**SOLICITATION AMENDMENT
MODIFICATION DE L'INVITATION**

Title - Sujet Electric Circulation Heater	
Solicitation No. - N° de l'invitation 23240-210631/A	Amendment No. - N° modif. 002
Client Reference No. - N° de référence du client 23240-210631	Date 2021-04-29
GETS Reference No. - N° de référence de SEAG PW-\$\$HL-676-79938	
File No. - N° de dossier hl676.23240-210631	CCC No./N° CCC - FMS No./N° VME
Solicitation Closes - L'invitation prend fin at - à 02:00 PM Eastern Daylight Saving Time EDT on - le 2021-05-10 Heure Avancée de l'Est HAE	
F.O.B. - F.A.B. Specified Herein - Précisé dans les présentes Plant-Usine: <input type="checkbox"/> Destination: <input type="checkbox"/> Other-Autre: <input checked="" type="checkbox"/>	
Address Enquiries to: - Adresser toutes questions à: Jougla (hl676), Jonathan	Buyer Id - Id de l'acheteur hl676
Telephone No. - N° de téléphone (613) 296-6827 ()	FAX No. - N° de FAX () -
Destination - of Goods, Services, and Construction: Destination - des biens, services et construction: See herein

QUESTION AND ANSWER – SERIES 2

3. At Annex "A" – Requirement, Attachment 1 to Annex A - Electric Heater Specification Sheet, ADD the following drawing,

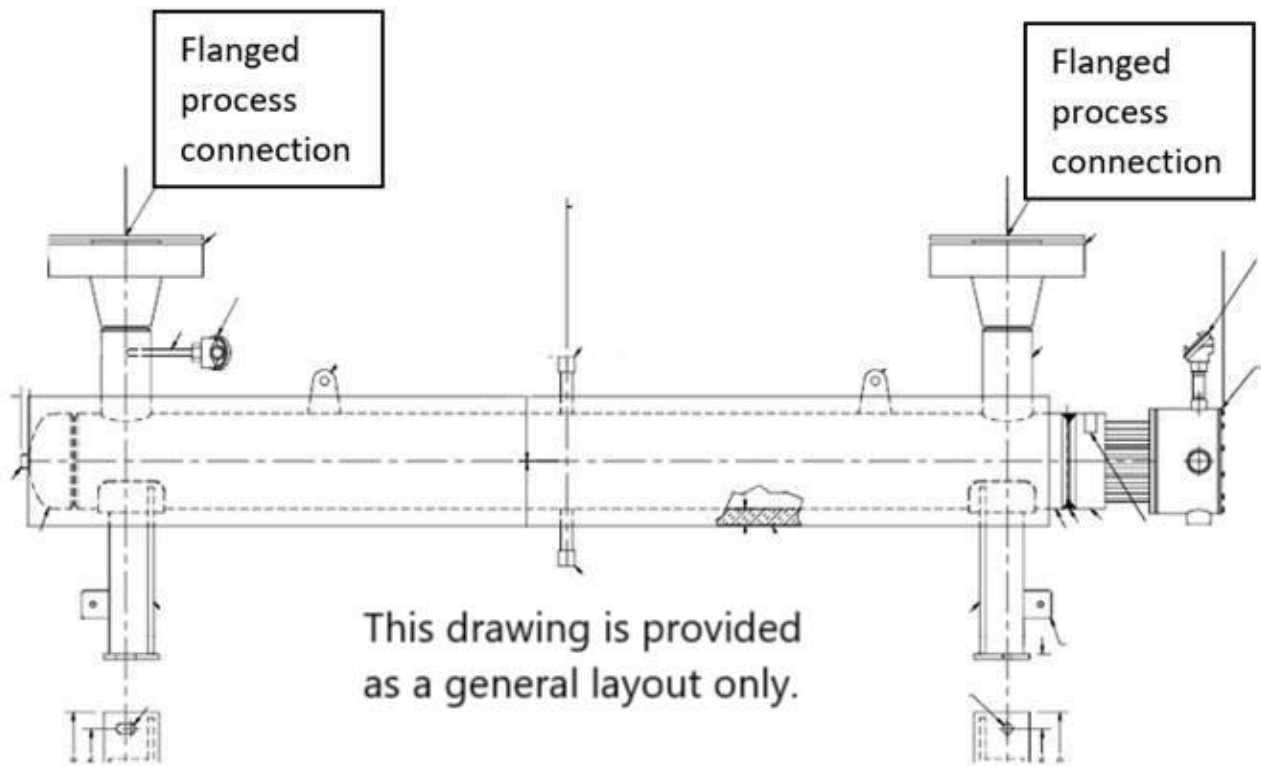
Q7. Could you provide a sketch of the general layout of the Heater?

A7. Please see amendment below.
